# RECORD OF DECISION

NYSEG - Palmyra MGP  
Operable Unit Number: 01  
Palmyra, Wayne County  
Site No. 859022  
March 2011

Prepared by  
Division of Environmental Remediation  
New York State Department of Environmental Conservation

DRAWING NUMBER	4
SHEET NUMBER	
REVISION

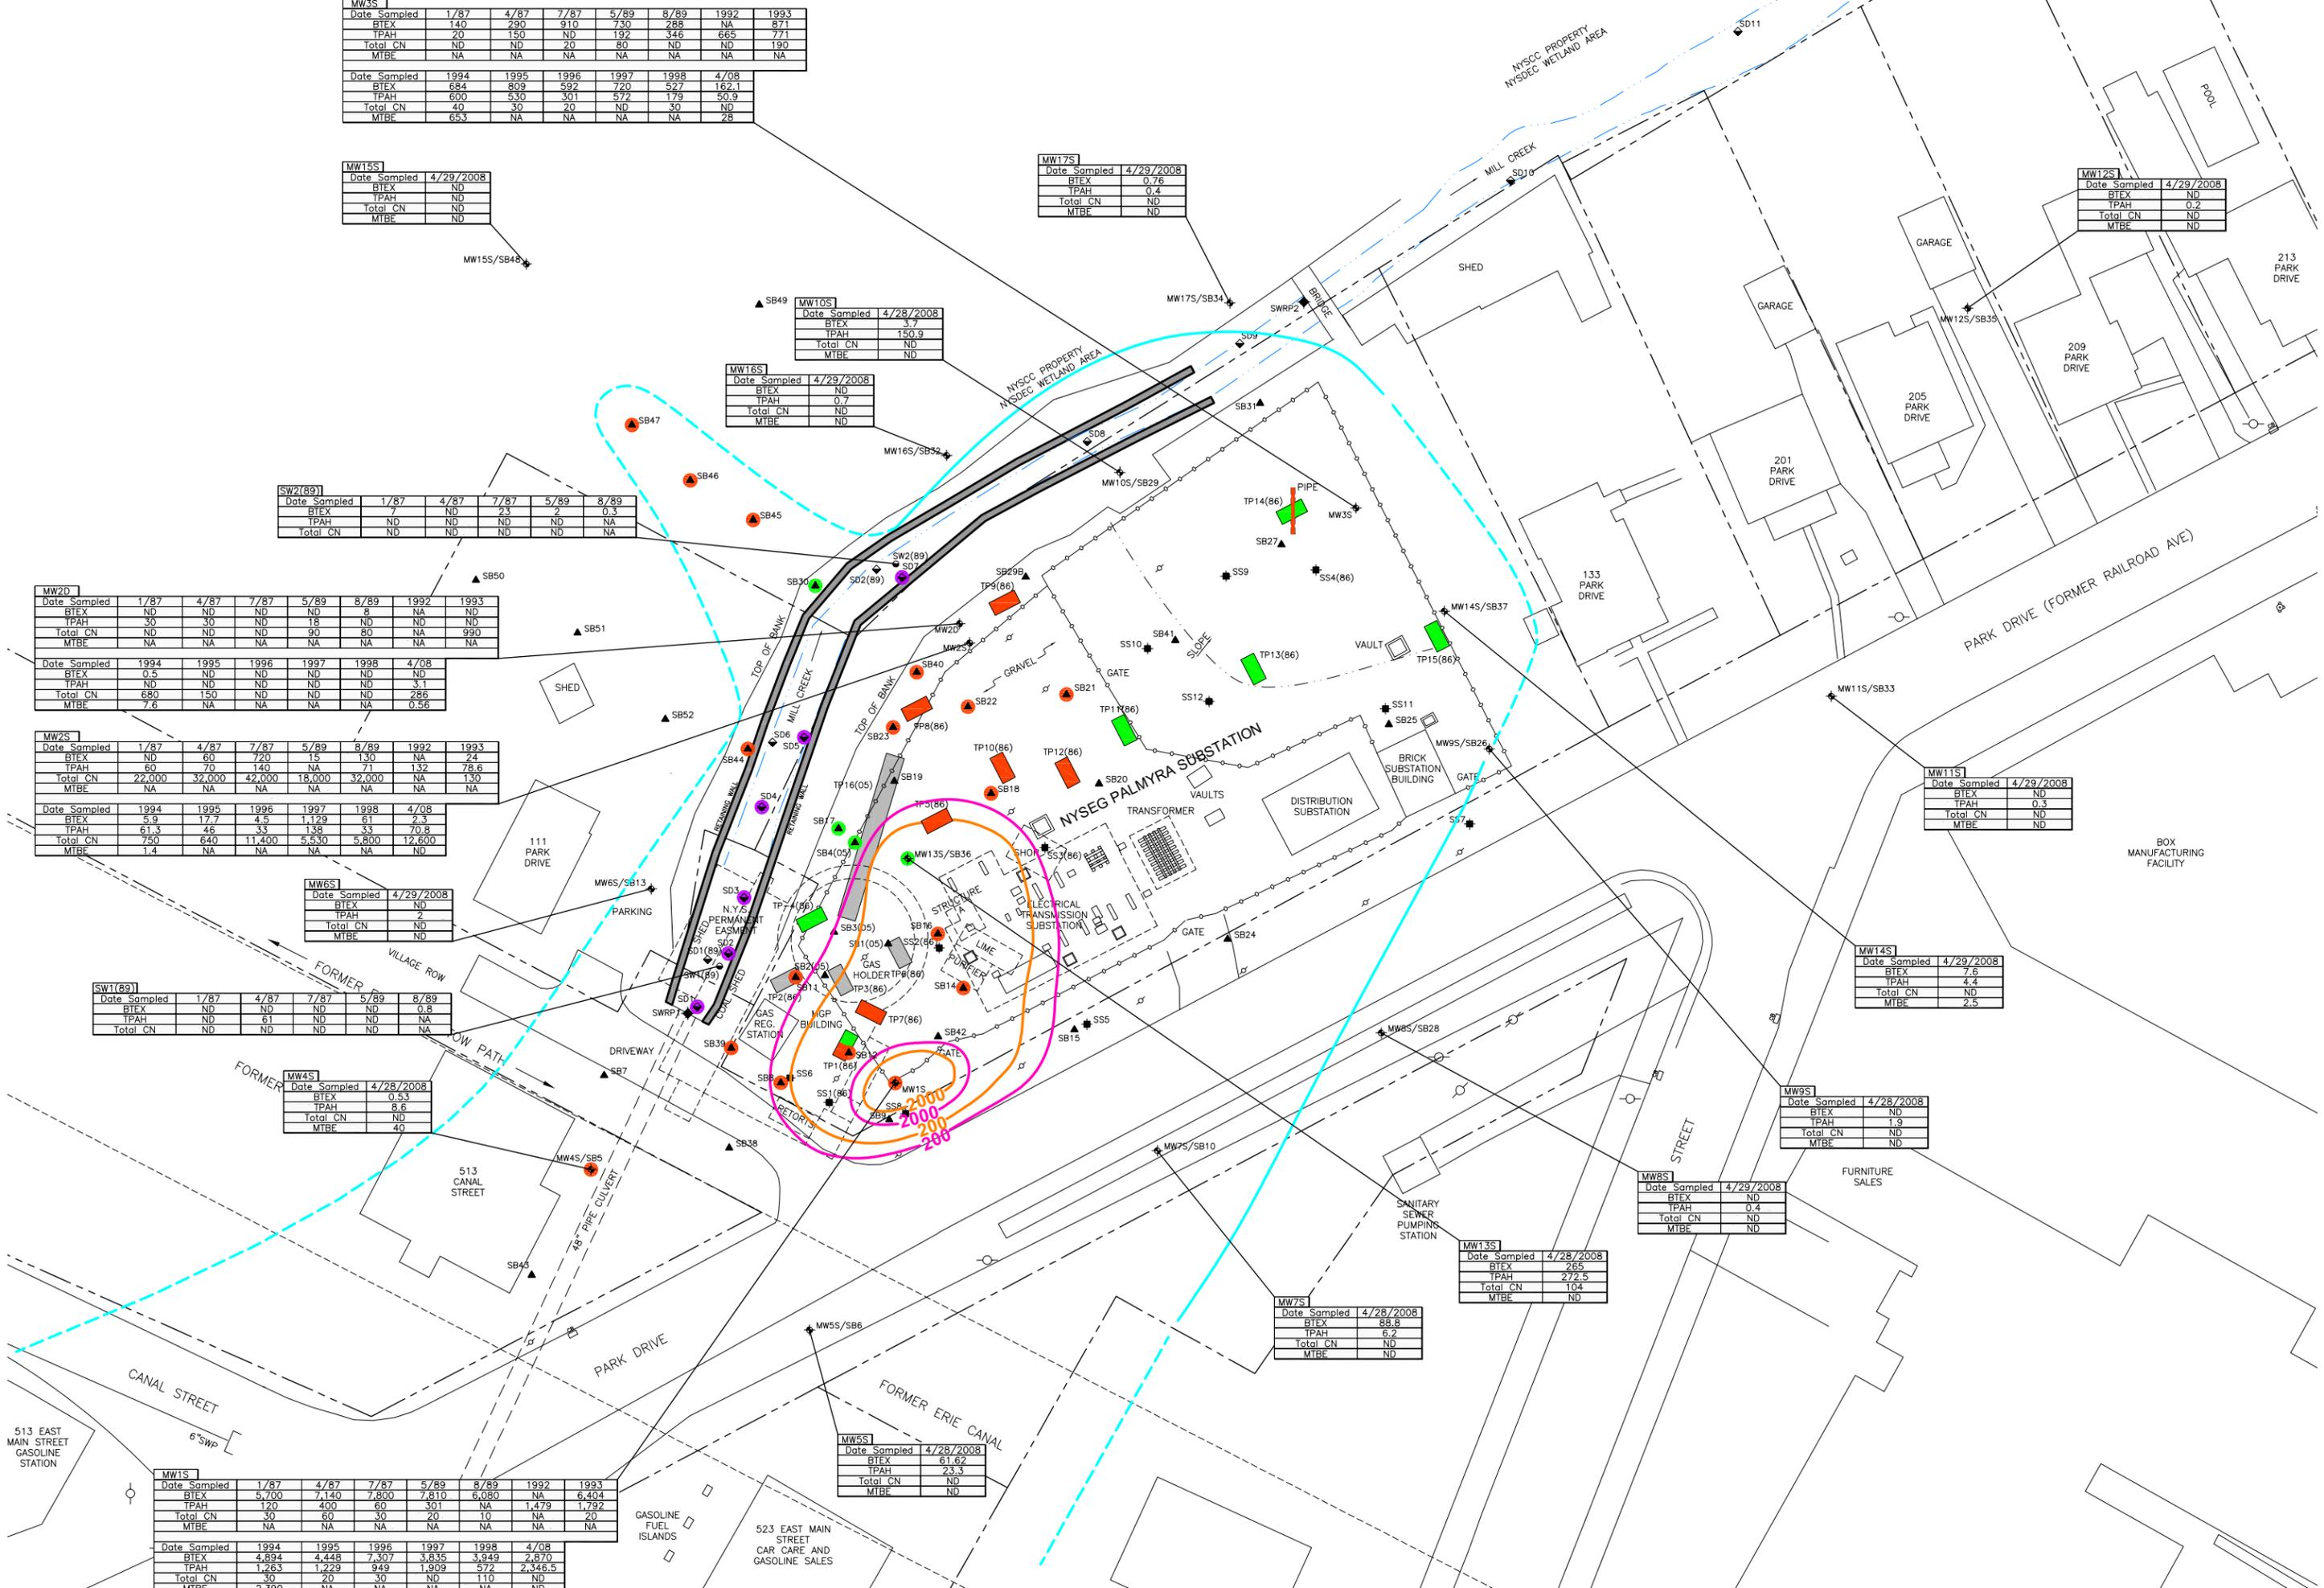
COMMENT 39: PRAP figures 4 and 5 both show excavation areas in Mill Creek; however, Section 3, page 3 states that Mill/Hathaway Creek will be designated as Operable Unit 2 (OU2) which is not the subject of the current PRAP.

RESPONSE 39: The ROD figures have been revised accordingly.
